APPLICATION FOR SUBMITTAL OF POST-APPROVAL DOCUMENT

South El Monte High School Modernization

CCD-21

Project Reference: South El Monte High School Modernization Date: 11/21/2023

MECHANICAL DEMOLITION ROOF PLAN - BLDG L
SCALE: 1/8" = 1'-0"

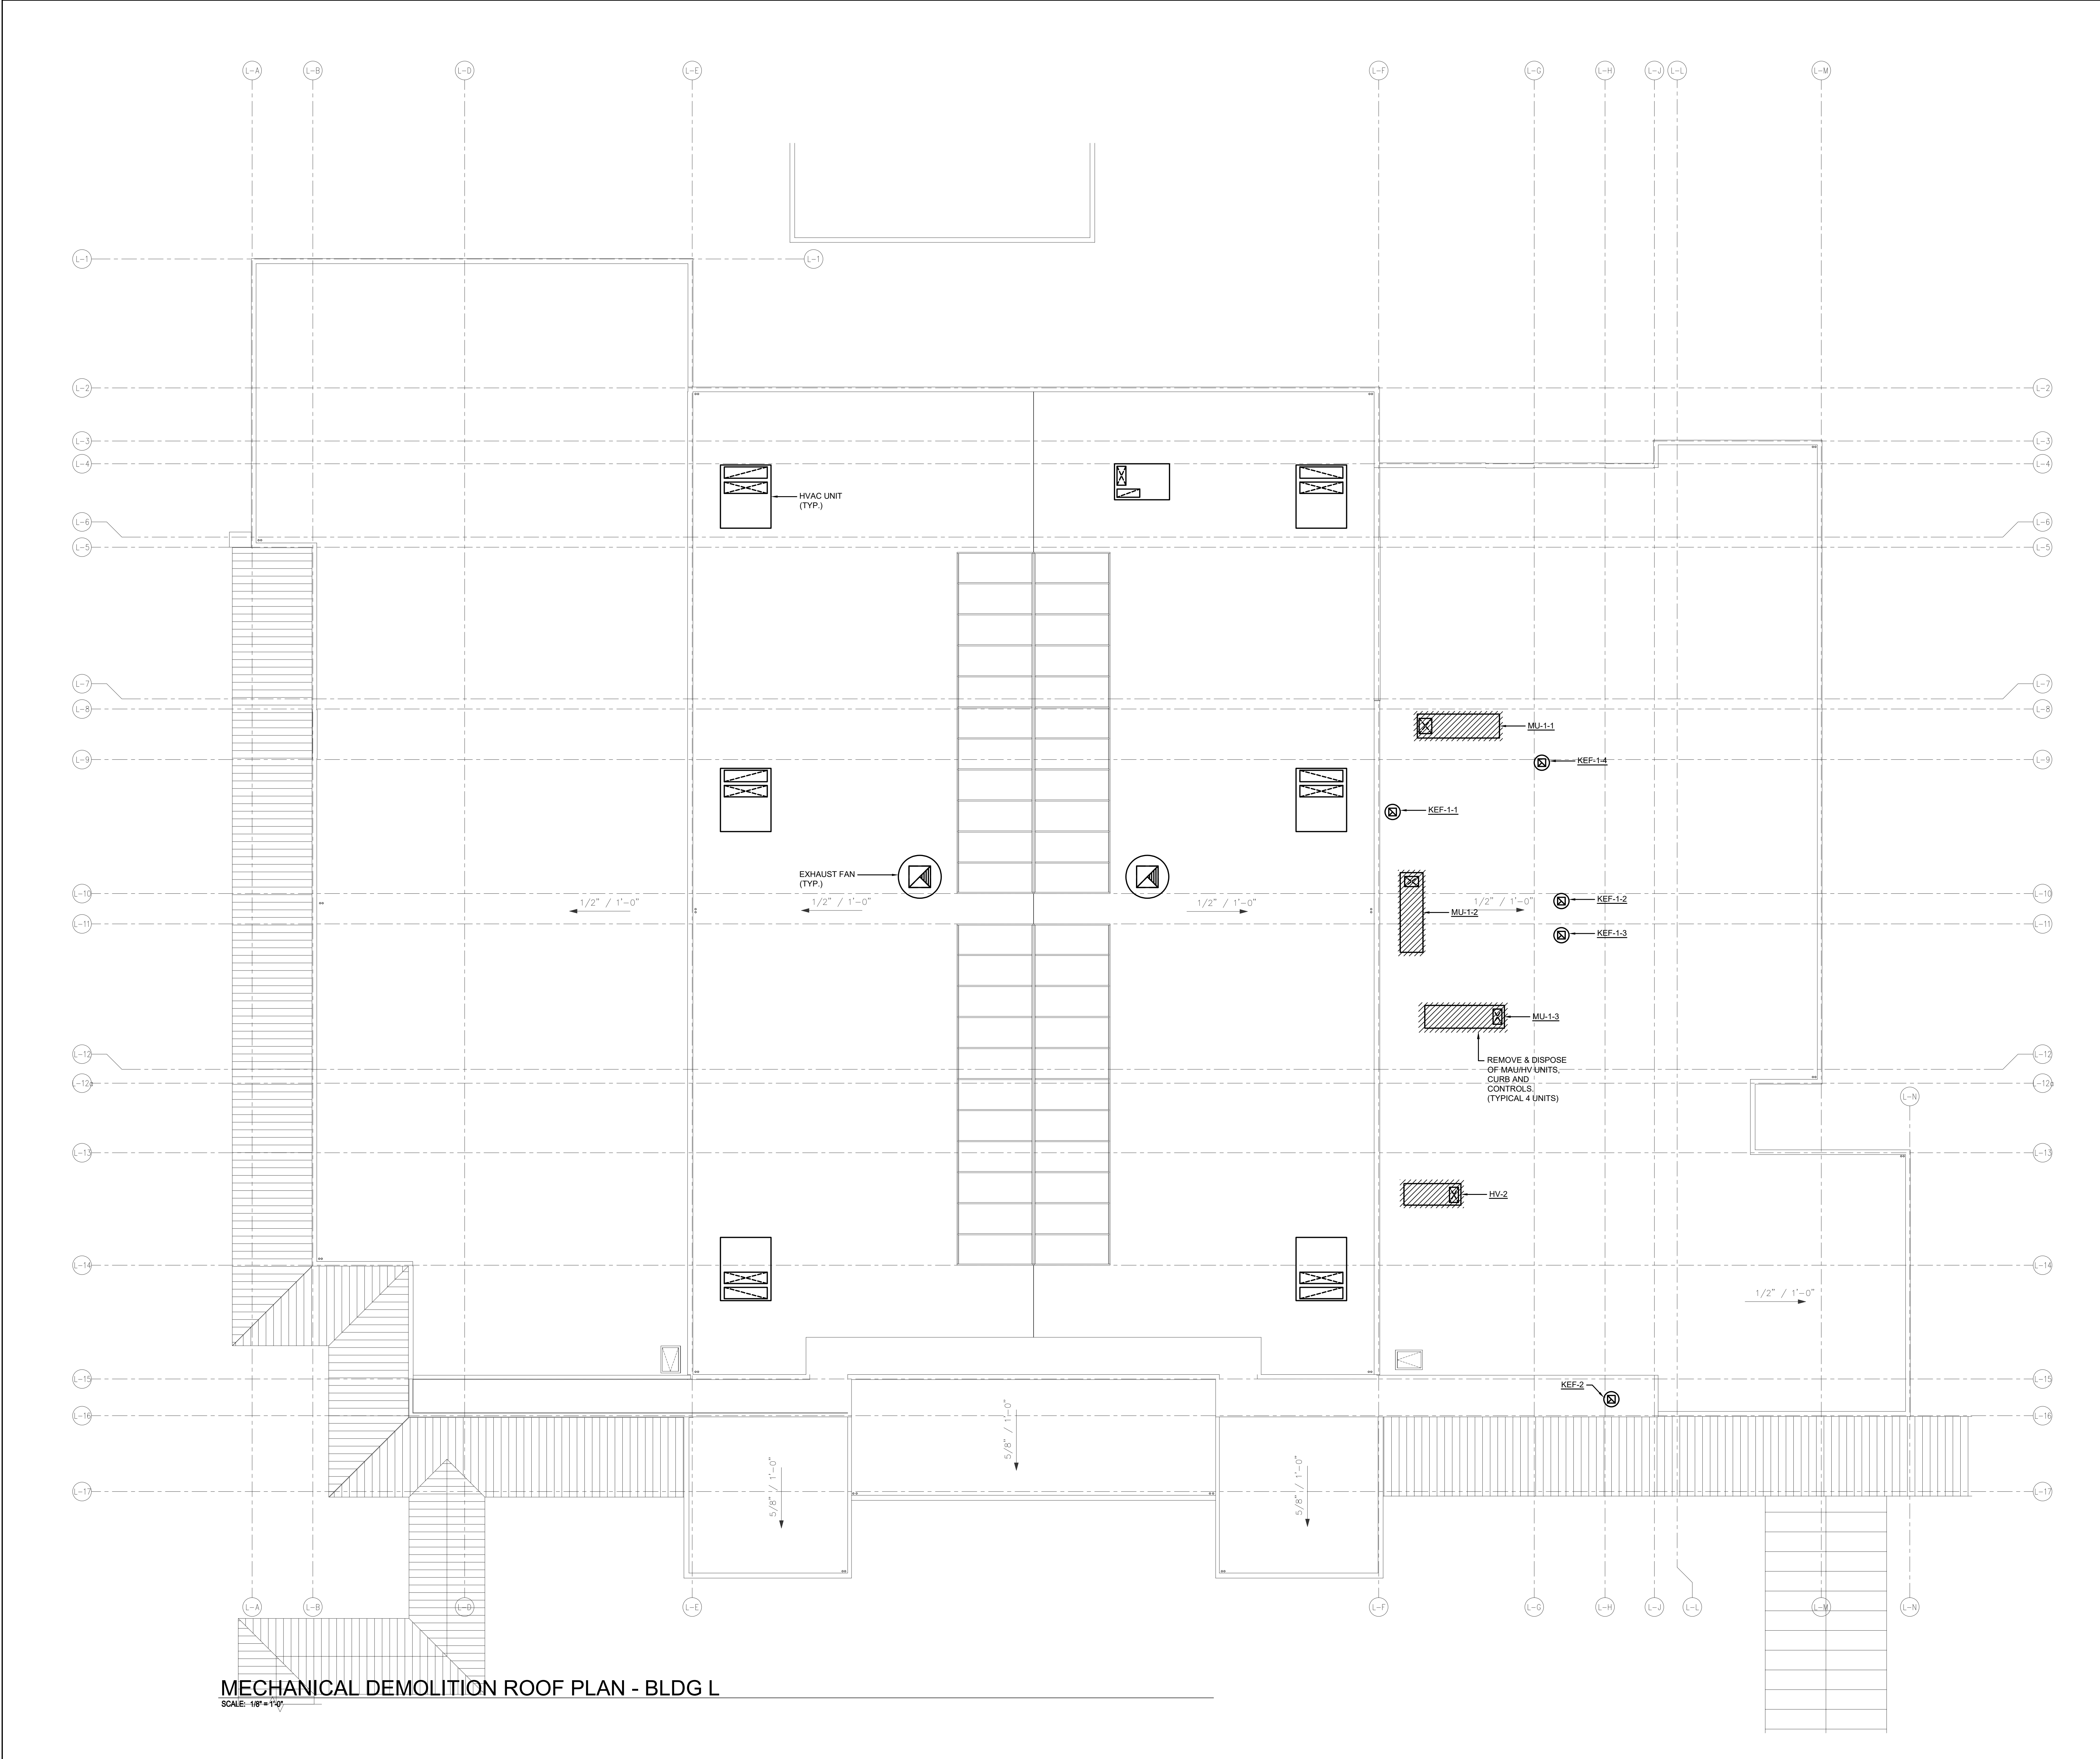
- 21.7. SHEET MD3.L1 – MECHANICAL DEMOLITION ROOF PLAN – BLDG L**
21.7.1. New sheet provided to identify demolition of existing RTU equipment above food service area.

MECHANICAL REMODEL FLOOR PLAN - BLDG L
SCALE: 1/8" = 1'-0"

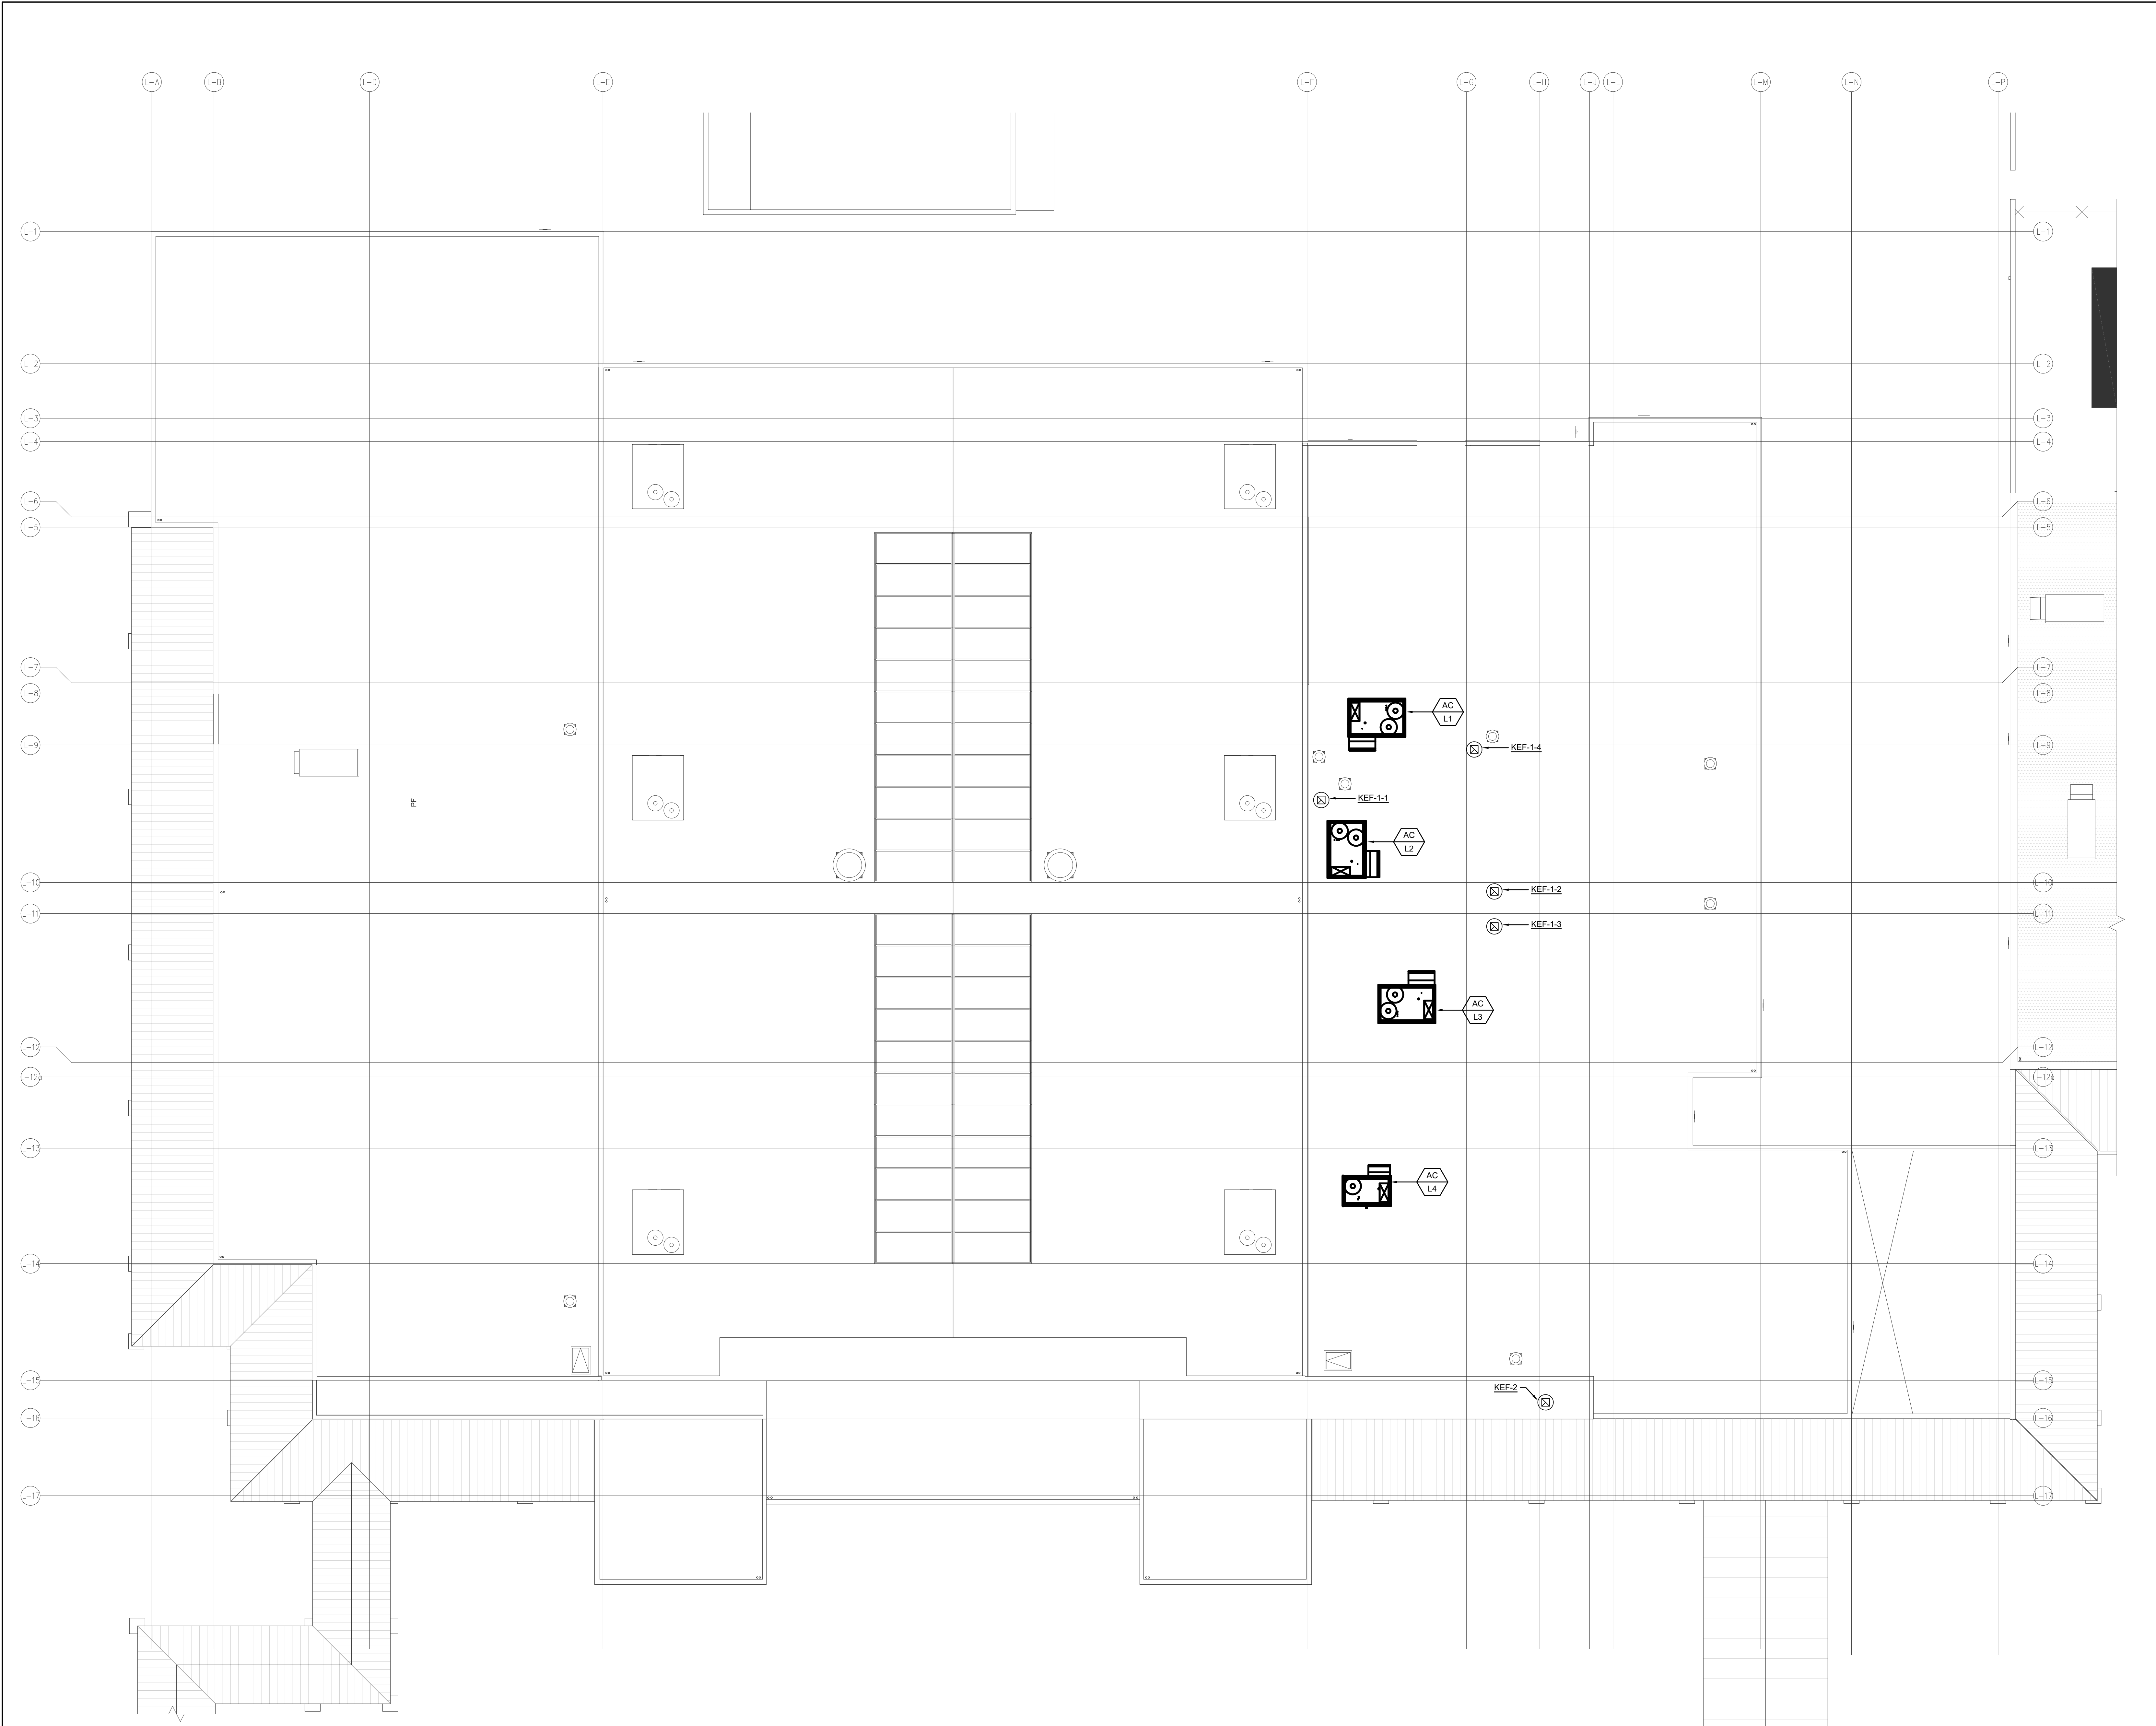
- 21.8. SHEET M2.L1 – MECHANICAL REMODEL FLOOR PLAN – BLDG L**
21.8.1. Identified the POC locations of the existing ducting in relation to the replacement RTU equipment on the roof.
